ADDENDUM #2
ITB/RFP NUMBER: 2022013-PW-B
Mountain View Drive Stream Restoration ITB

City of Harrisonburg’s ITB, is modified as follows:

REVIS
PROJECT MANAGER: JRR
DESIGNED: WKM/CKA
DRAWN: JAT/CKA
PROJECT #: 18-0022
DATE: 09/01/21
SHEET:
11

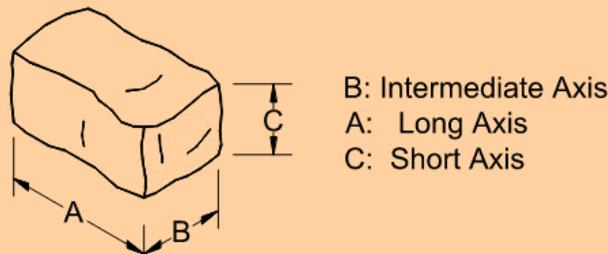
3. Question: Note 5 on Riffle detail on Sheet 9 dated 09/01/21 state that “Riffle mix shall be a minimum thickness of twice the specified D50 of the material or 2’, whichever is larger.” Riffle gradation table on sheet 11 dated 09/01/21 indicates % Fines and size(IN) of material for reach 1 and 2. Please verify if the size of material on table is the actual D50 dimension or the D50 dimension already multiplied by 2. If possible please provide D50 of material for Reach 1 and Reach 2.

Answer: The D50 size of the riffle material is specified in the “CUMULATIVE % FINER” “50” row and is 12” and 18” for reach 1 and 2 respectively. The riffle thickness identified on sheet 9 refers to the depth of riffle material placed and not the size of the material.

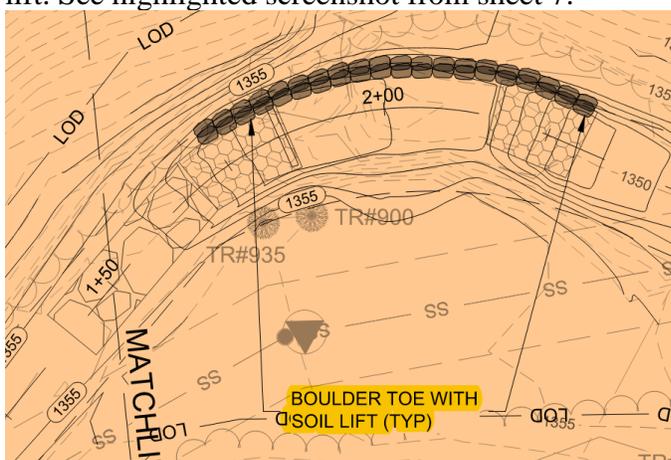
5. Question: For cascade detail on sheet 10 dated 09/01/21 please verify if boulder dimension table on sheet 11 dated 09/01/21 is applicable to boulders required for cascade detail.

Answer: Yes, boulders for the Cascade (C) structure must conform to the boulder dimensions provided on sheet 11.

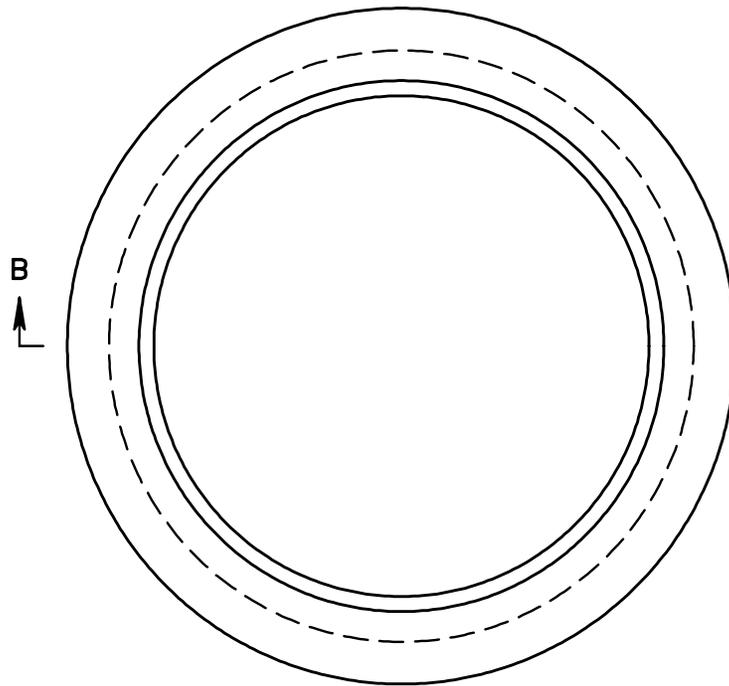
29. Question: Item 11 'Riffle' is a quantity of 19; however, I'm only counting 18 riffles on the plans/profile. Can you please provide stationing for all the riffles to confirm the quantity is correct.

Answer: There are a total of 19 riffles. 18 riffles are on the main stem of the project, and one riffle is to be constructed on the tributary located at approximately STA 2+30. All riffles are identified using the hatch shown on sheet 2.

STANDARD INLET AND FRAME COVER

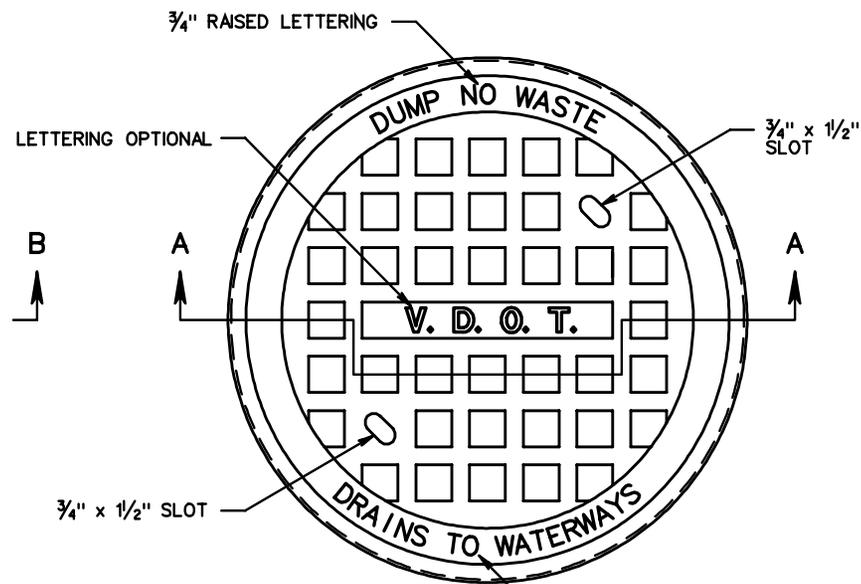
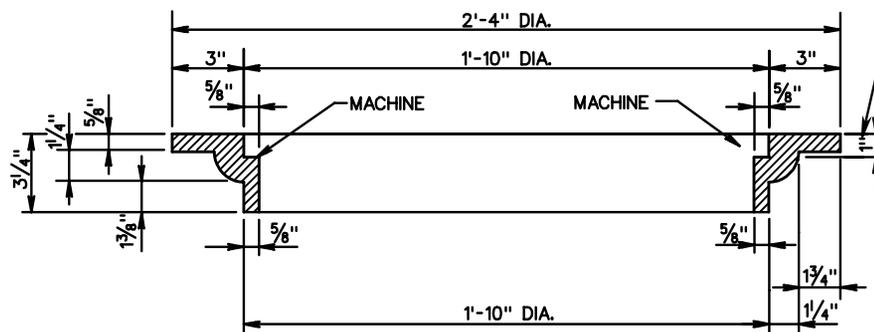
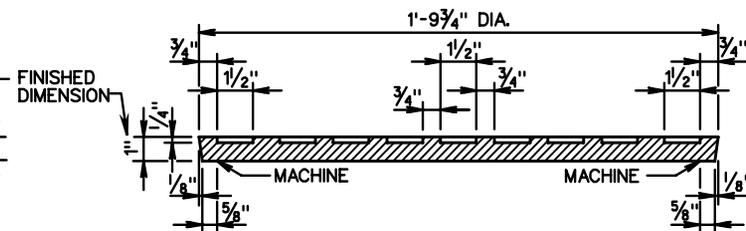
7. Question: On sheet 13 dated 09/01/21 please provide detail for IC-2. Sheet has 2 details for MH-1.

Answer: See attached IC-2 detail.
